## Department of Transportation

#### MEMORANDUM

**SUBJECT:** BZA Case No. 20643 – 5901 Utah Avenue NW (Maret School Athletic Field)

**Figure 1 | Site Plan and Curbside Plan**

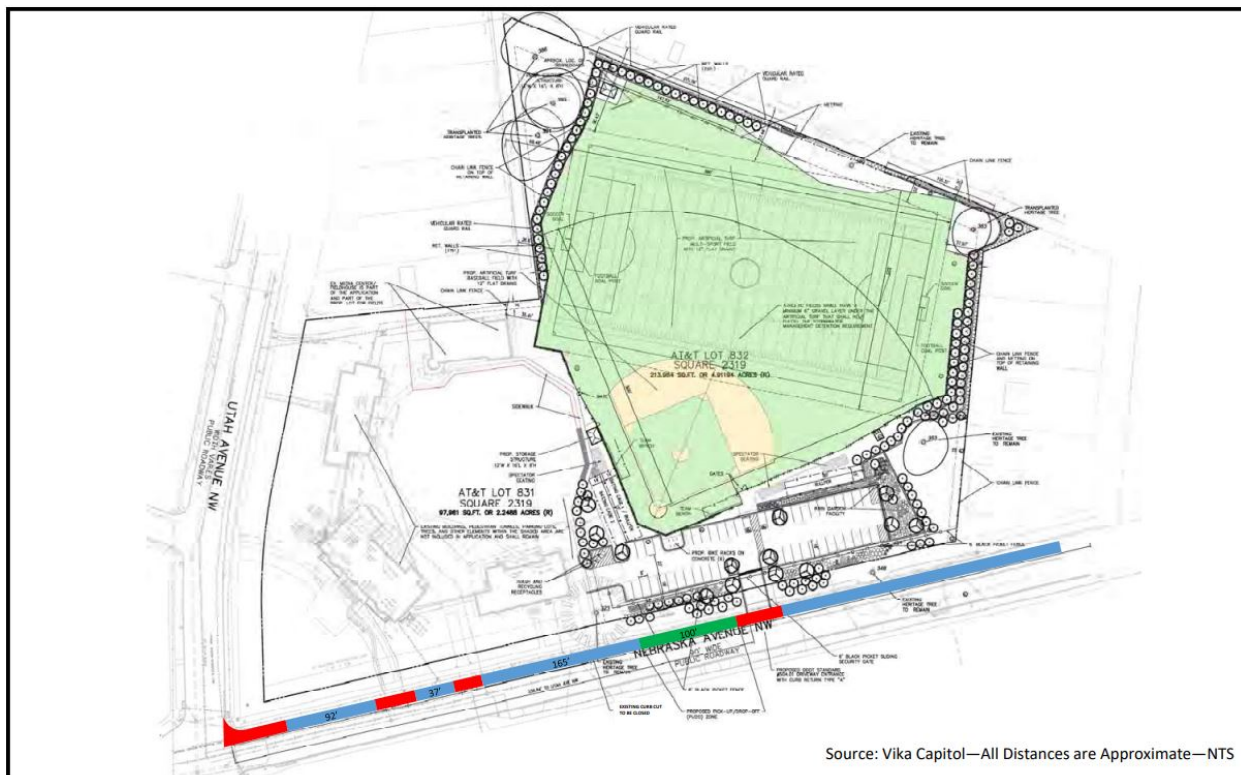
While the preliminary public space plans, shown above in Figure 1, are generally consistent with DDOT standards, there are a few considerations that need to be reviewed in greater detail during the public space permitting process:

- DDOT concurs that the existing curb cut on Nebraska Avenue NW should be closed. The existing driveway in public space and within the Building Restriction Line dimension should be removed and replaced with green space and a street tree in the furniture zone;

- Ensure there is a leadwalk to the sports field for pedestrian access. The design will be reviewed in the public space construction permit application;

- The public space permit application should include designs of all bicycle and pedestrian network improvements included as BZA conditions;
- Submit a curbside management plan for the curbside designations along Nebraska Avenue NW including any pick-up/drop-off zones. Applicant will be required to fund and install any changes to signs or meters; and

- The garden at 5860 Nebraska Avenue NW, within public space, will be disturbed by the installation of a gas line. This garden should be shown on the public space plans and substantially restored after construction of the gas line.

**Figure 4 | Existing and Proposed Bicycle Facilities**

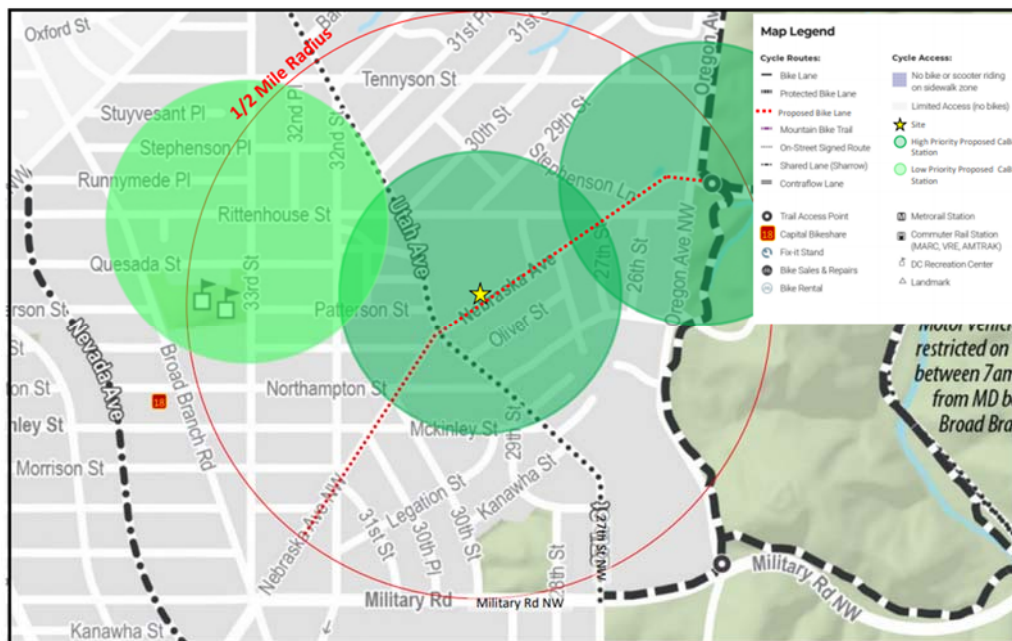
The District is committed to enhancing bicycle accessibility by ensuring consistent investment in bicycle infrastructure on the part of both the public and private sectors. DDOT expects new developments to serve the needs of all trips they generate, including bicycling trips. As shown below in Figure 4, there are currently no bicycle lanes or Capital Bikeshare stations in the vicinity of the site. DDOT has identified Nebraska Avenue as a future bicycle connection but has not identified the timeframe for planning or the type of facility. DDOT has also identified this area as a high priority for Capital Bikeshare and will work with the Applicant to identify a location for a new Capital Bikeshare station.

- Fund and install a 19-dock Capital Bikeshare station with 12 bikes and one (1) year cost of maintenance and operation; and
- Install a minimum of eight (8) inverted-U bicycle racks for a minimum total of 16 short-term bicycle parking spaces.
